PROPOSED MIXED-USE DEVELOPMENT, WHALLEY TRANSPORT ASSESSMENT ADDENDUM NOTE REV A

VN91274 – TA Addendum Note Rev A

4. Comments (dated 7th January 2020) on the TA were provided by Lancashire County Council (LCC) Highways Development Control Officer, Neil Stevens, and these are provided at **Appendix A** to this Note. Subsequently, Vectos met with Neil Stevens on the 19th February 2020 at the RVBC offices in Clitheroe to discuss the comments, and further dialogue has taken place over the course of 2020, with further information provided to LCC Highways through a TA Addendum Note in July, to which comments were provided by LCC Highways in October 2020. This revised TA Addendum Note therefore responds to all the comments received from LCC Highways to date.

DRAWING TITLE:
**Proposed 4th Arm off
A59/A671 Roundabout
Swept Path Analysis (4)**

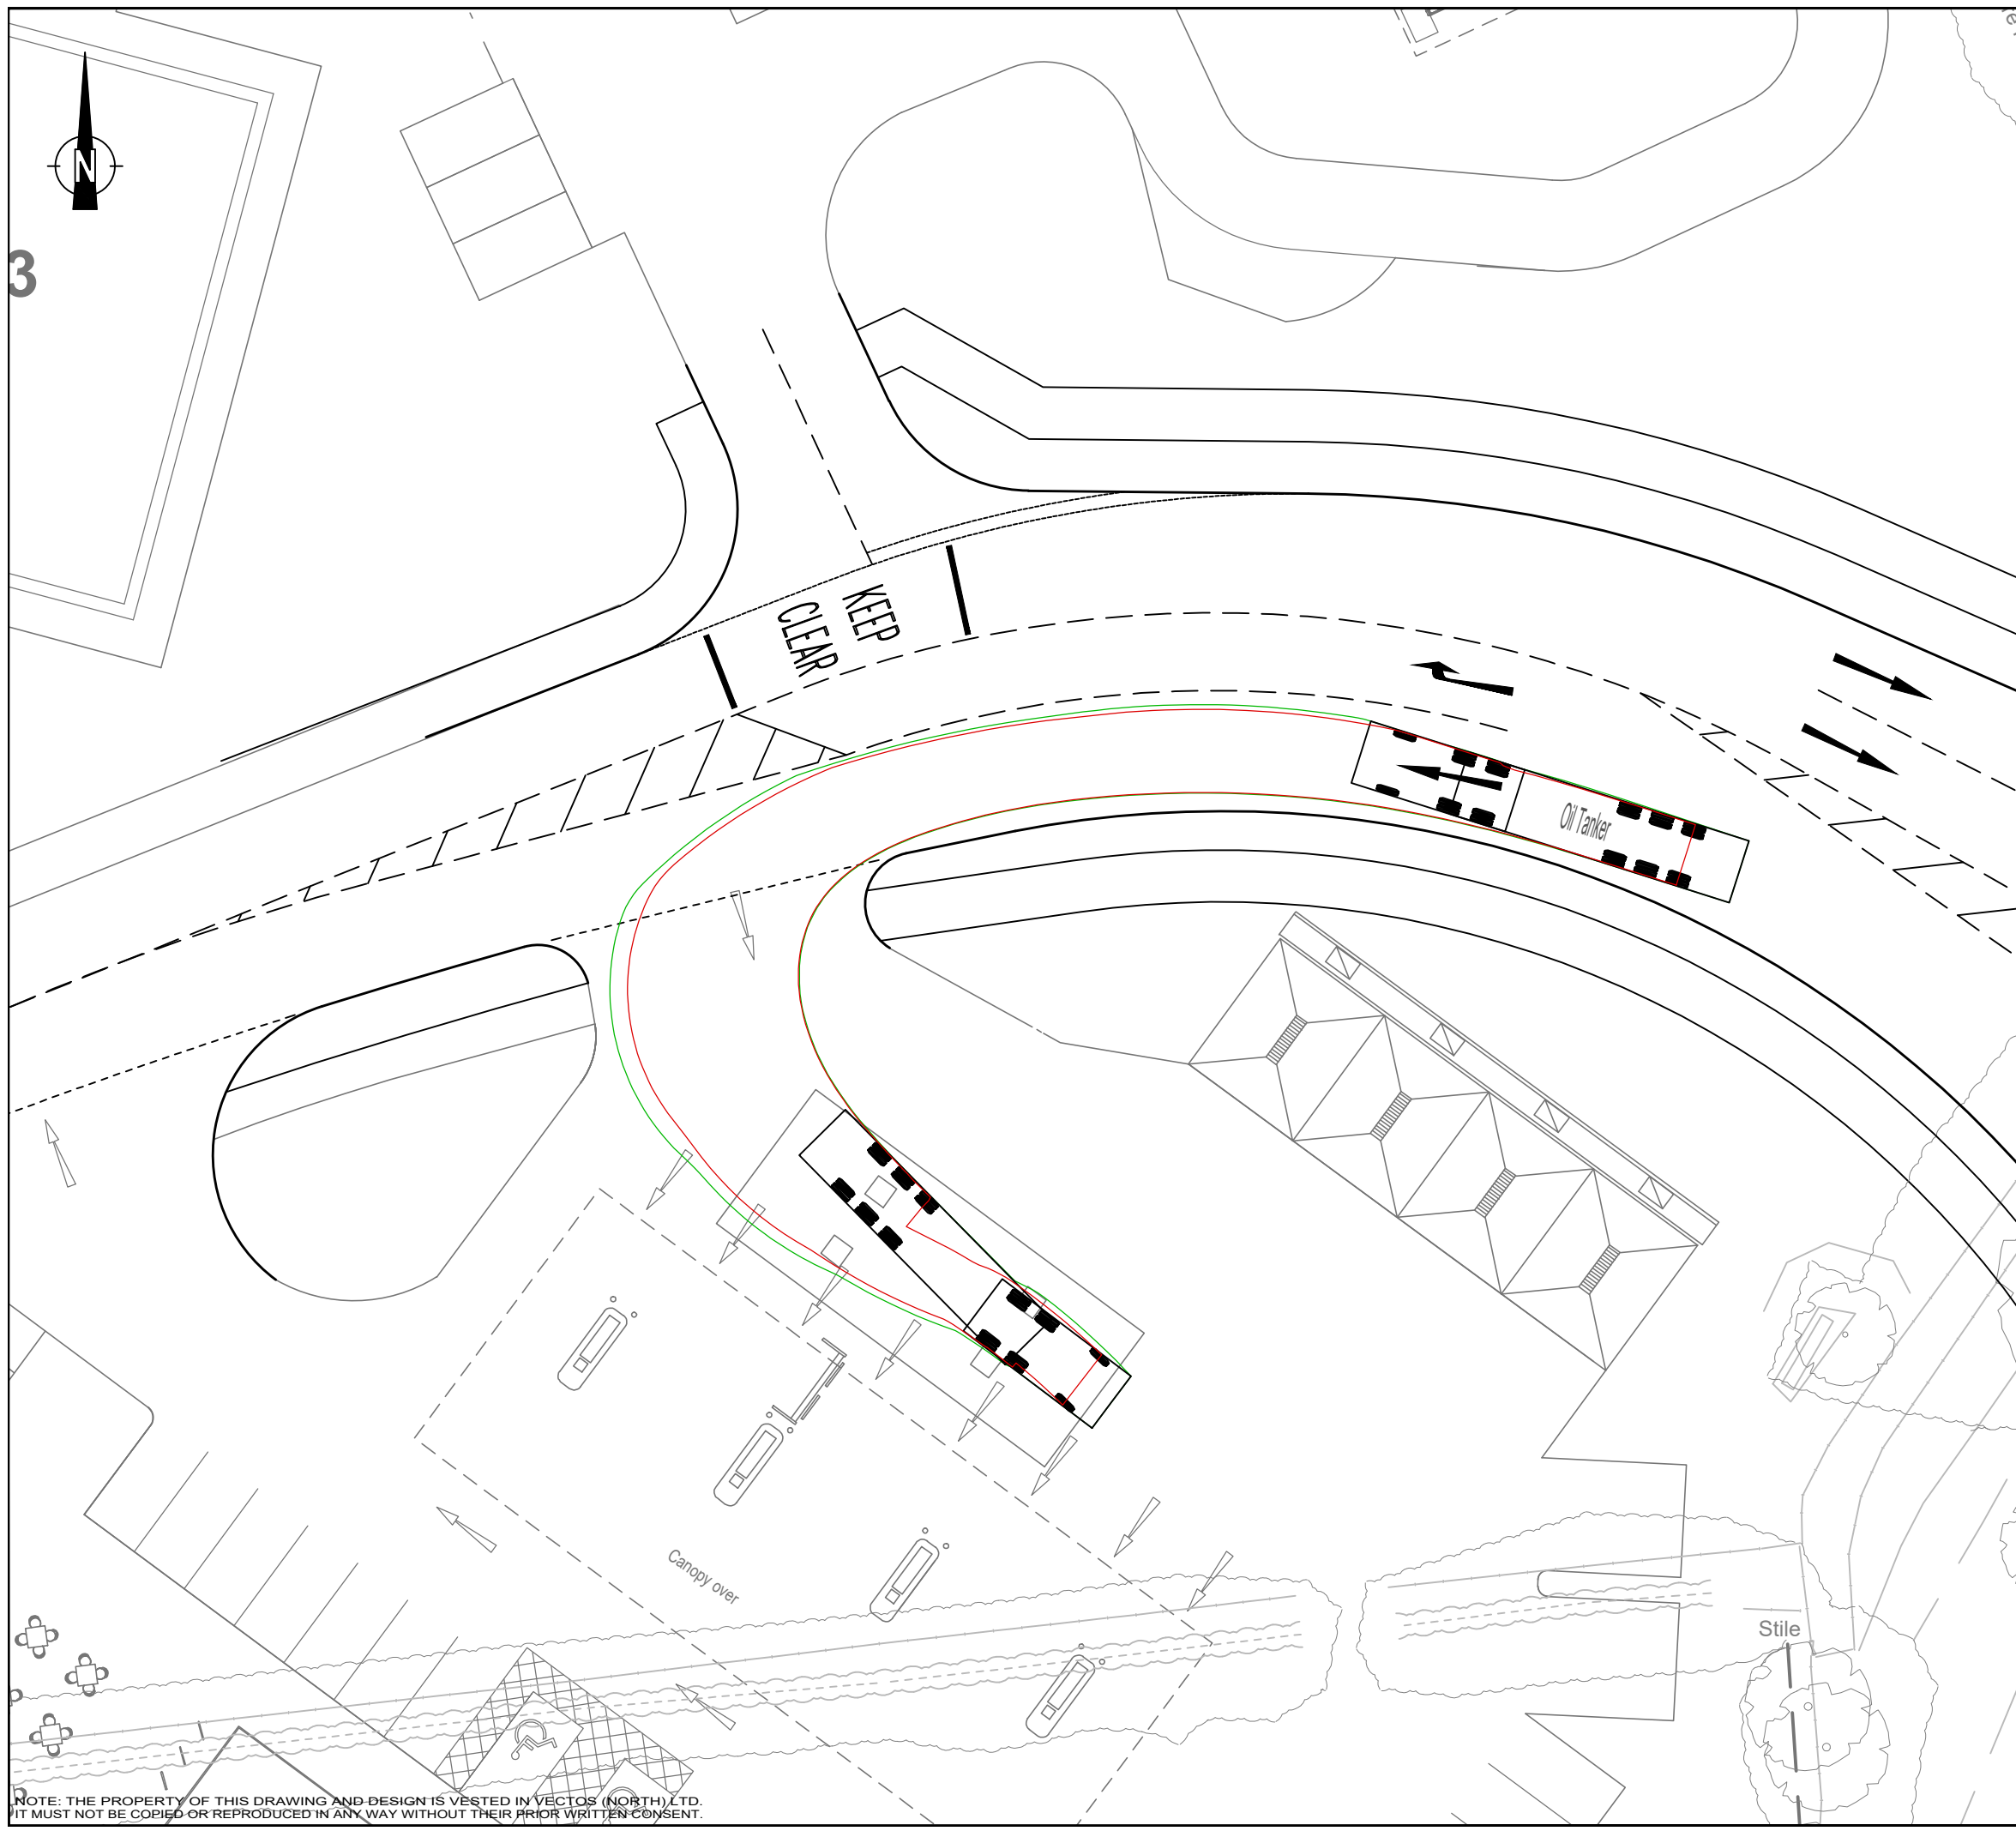
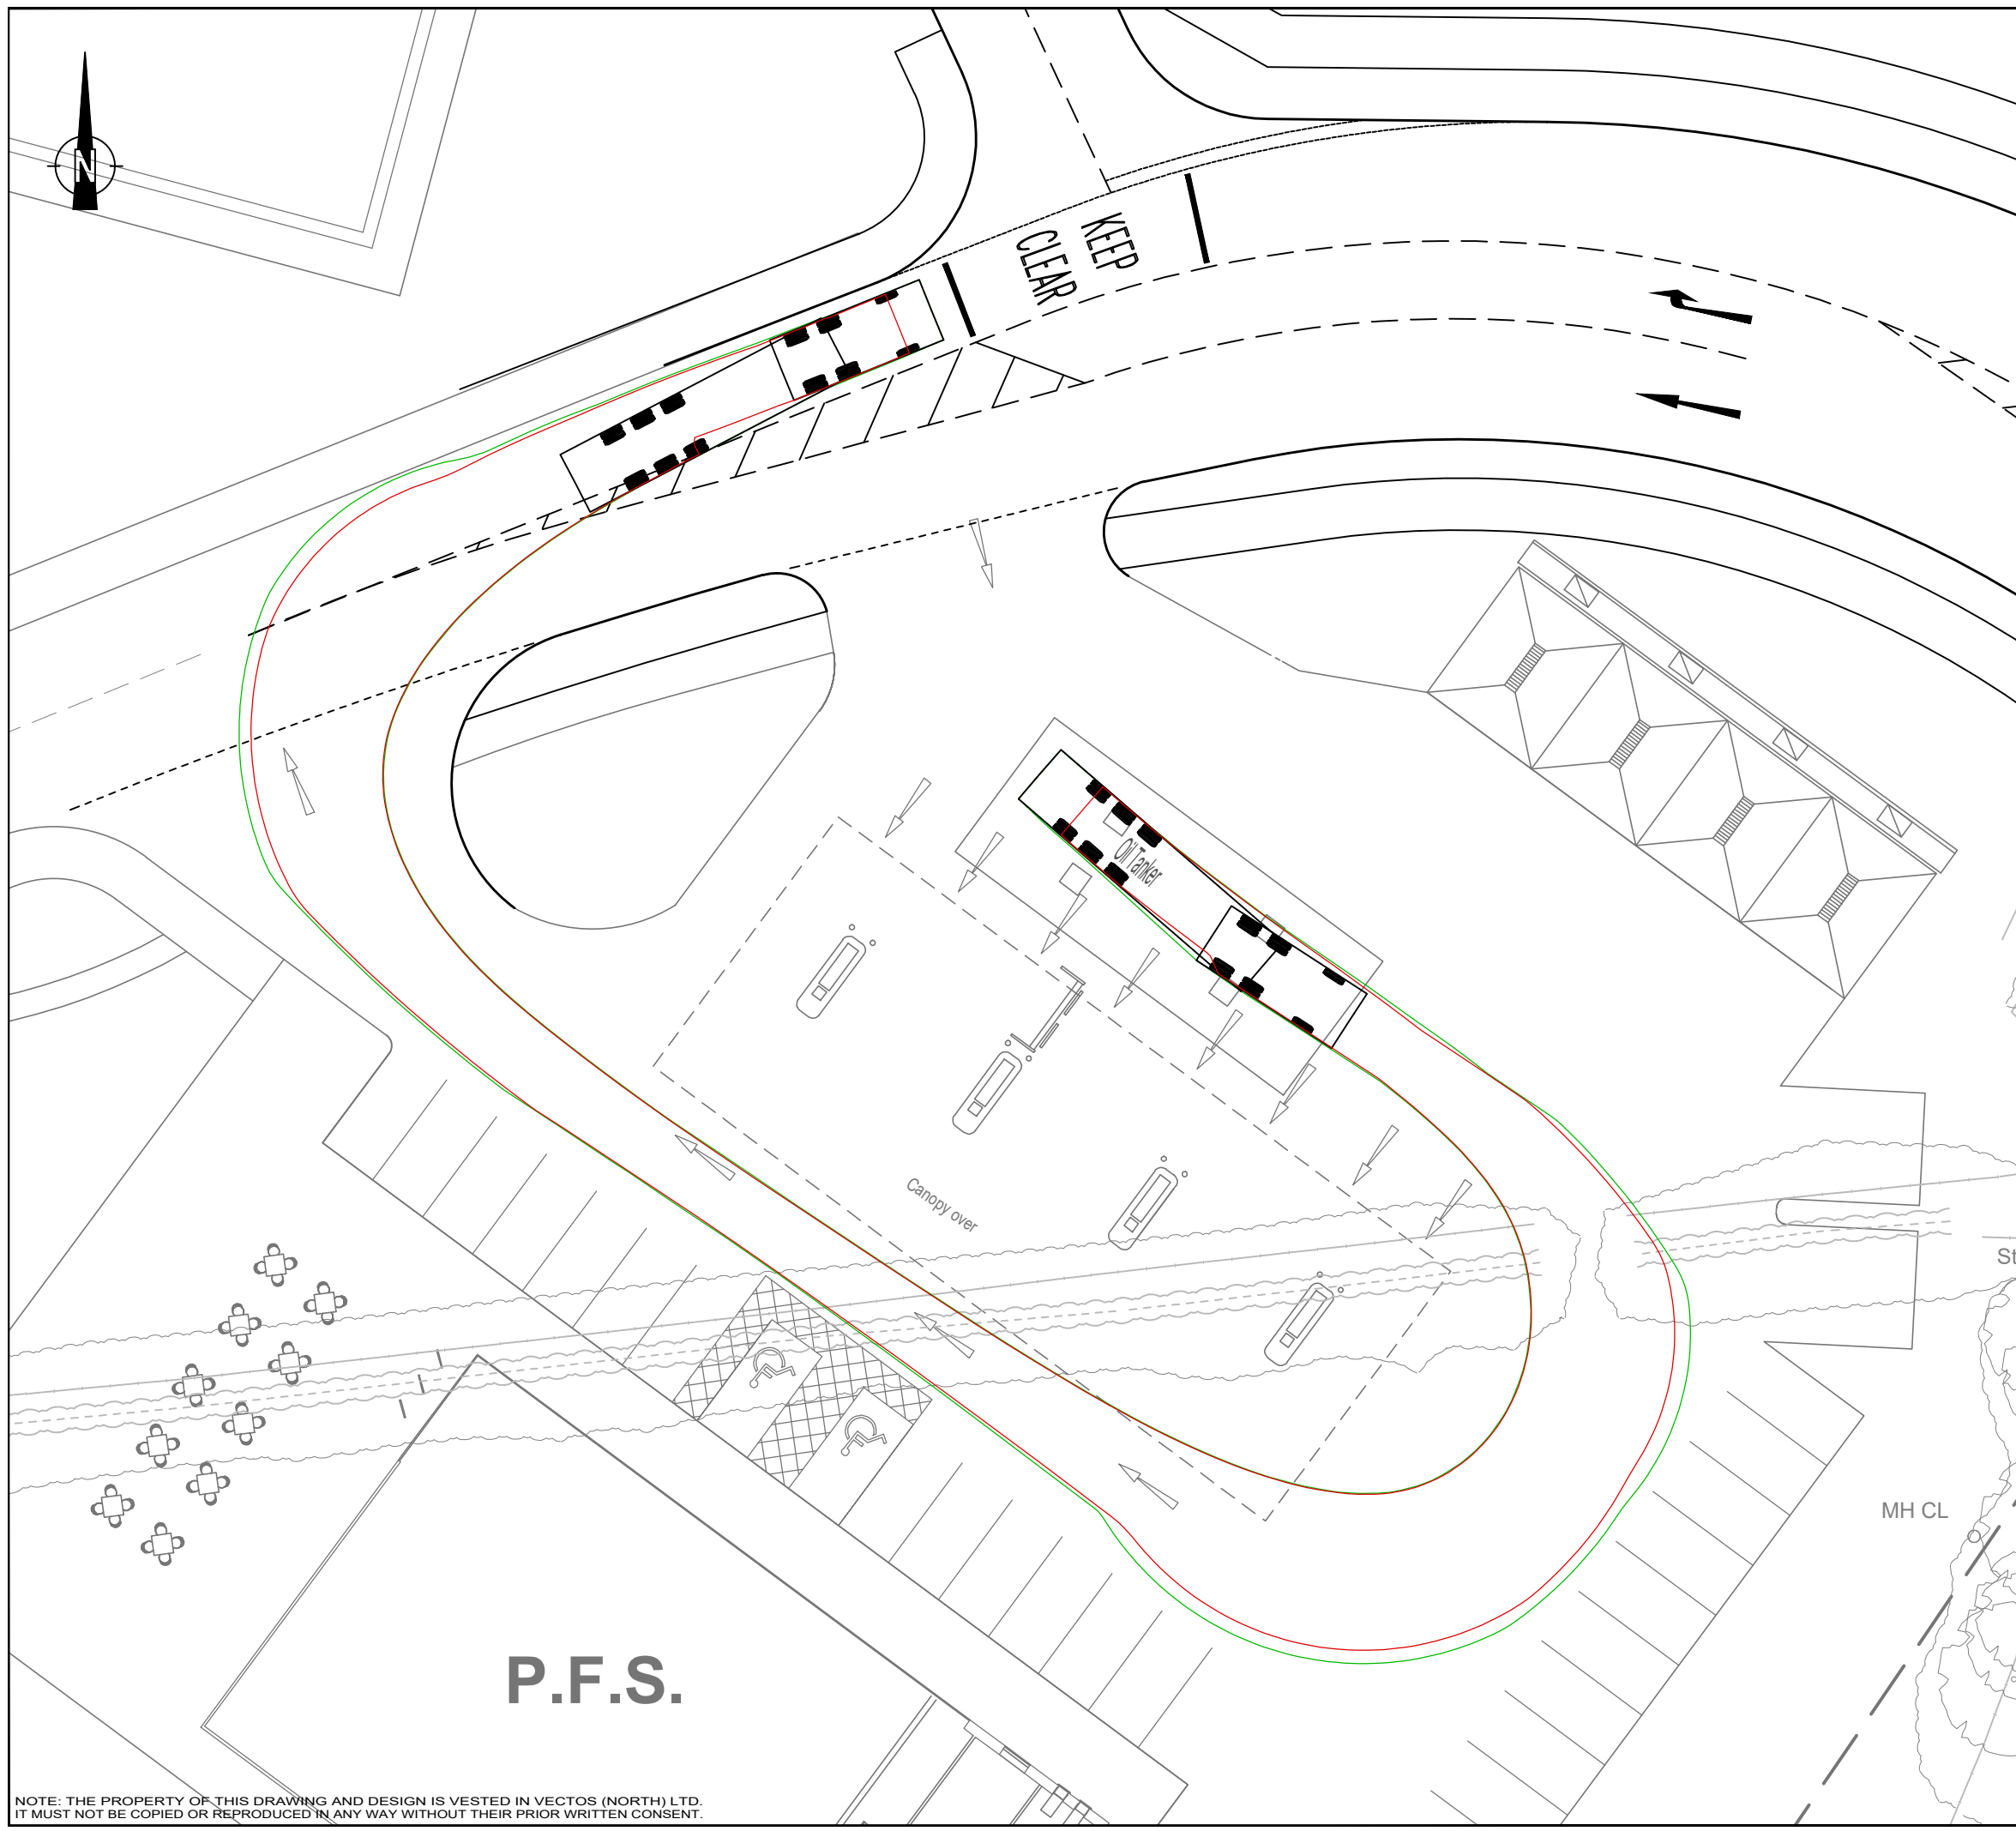
17. Consideration has been given to the operational aspects of the PFS in highway terms, and the following commentary is provided:
- The proposed fourth arm access road can accommodate fuel tanker movements and at times of fuel deliveries, cars could still be allowed to enter the PFS but be immediately directed to the exit using cones or similar. This ensures traffic would not stop on the access road and seek to turn around with a reverse manoeuvre. A swept path assessment showing a fuel tanker vehicle accessing and exiting the PFS is shown in **Drawing VN40390-SK001/SPA-4** and **Drawing VN40390-SK001/SPA-5**.
